WAQ1 - Albuquerque, NM
7300 Meridian Pl NW
Albuquerque, NM 87121

Sheet Title
SITE PLAN
Sheet No.
SPBP_001

Plans for parking lot expansion at the address mentioned above have been revised in accordance with the City review comments received on 10/27/2020. The written response following the City comment (in **bold**) is to indicate the action taken to address each comment. The numbering system utilized corresponds to the City review comment numbers.

Re: 7300 Meridian PI NW—Planning Comments
(Project Number: PR-2020-003650, Project Name: SI-2020-01060)

SIGHT TRIANGLE (TYP)

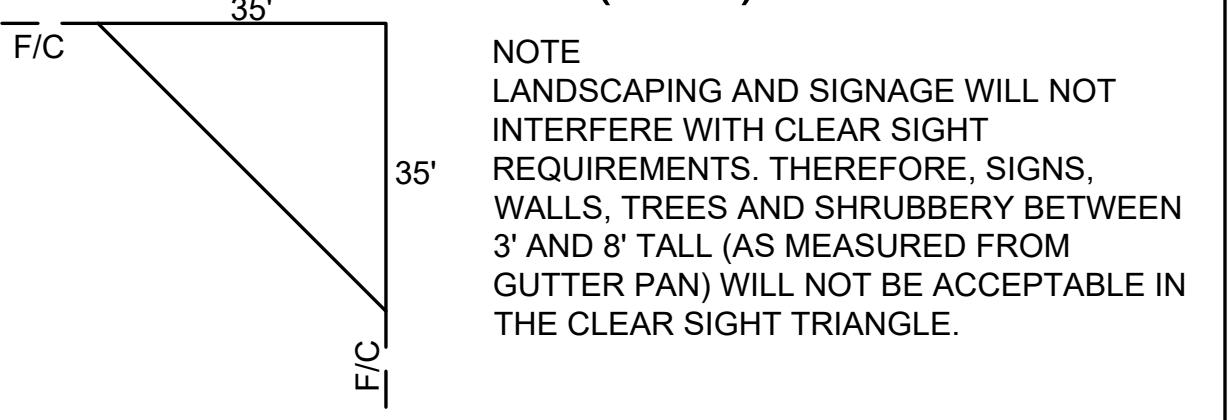
1. Show clear sight triangles on landscaping plan for accessways to match the site plan. Add note, "Landscaping and signage will not interfere with clear sight requirements". Therefore, signs, walls, trees and shrubbery between 3 and 8 feet tall (as measured from the gutter pan) will not be acceptable in the clear sight triangle. Also show a clear sight distance triangle on the westernmost accessway off of Meridian on the site plan

Response: Clear sight triangles are shown and all vegetation within triangles have been relocated.
2. Due to landscaping plan, also provide clear sight triangles at the intersection corners

6 4FT WROUGHT IRON FENCE
1/2" = 1'-0"

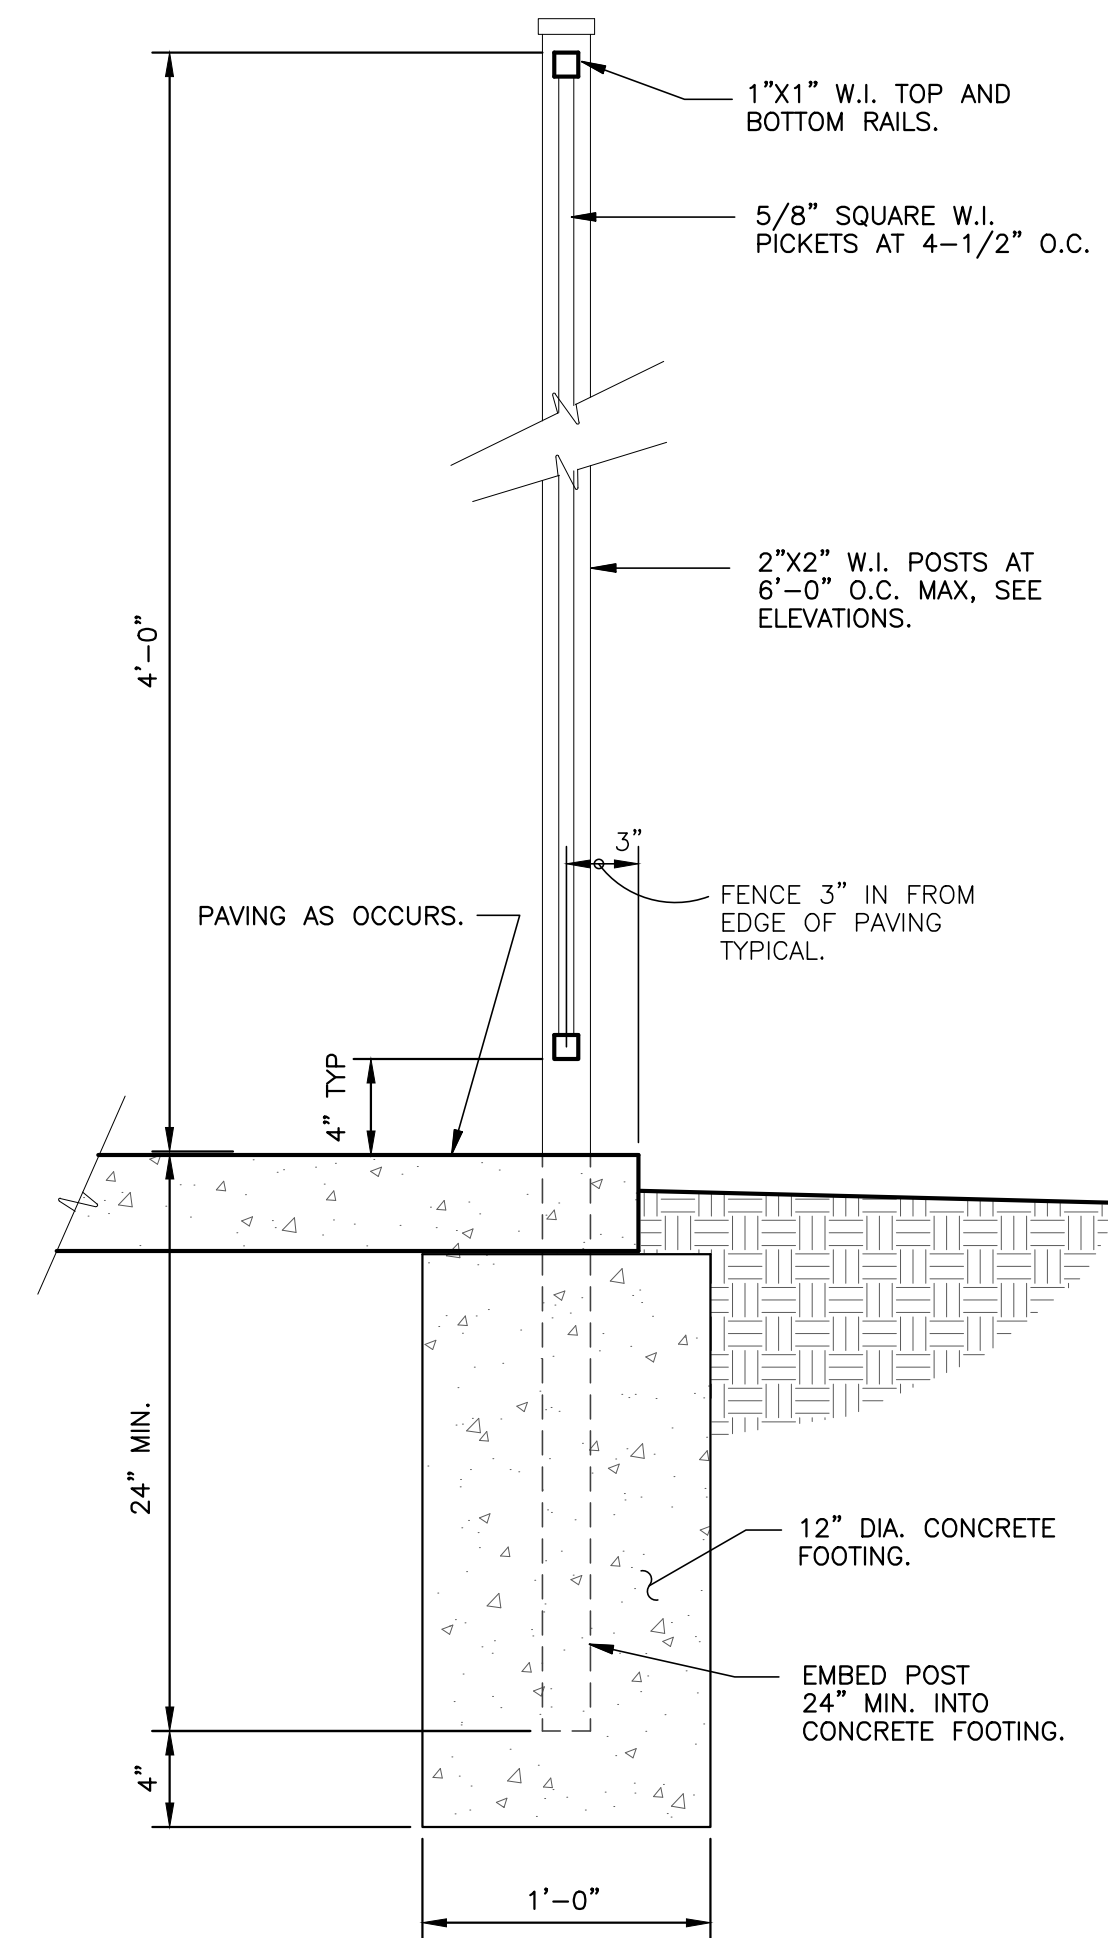
1. All plans must be stamped and sealed by an architect, landscape architect or engineer depending the plan type.
Response: Updated plans are stamped and sealed by architect, civil engineer and landscape architect.
2. The Atrisco Business Master Plan requires 1 tree per every 40 feet of linear feet of site perimeter – please clarify how this requirement is met.
Response: 1 tree is provided per 40 linear feet of perimeter, see Landscape Requirement Table on Land_002
3. Confirm that parking lot trees are provided at 1 tree per each 10 parking spaces and that no space is more than 100 feet from a parking space.
Response: Parking lot trees are provided at 1 tree per 10 parking spaces, see Landscape Requirement Table on Land_002
4. Was a fence detail provided?
Response: Plans have been updated to show a fencing detail. See Land_003
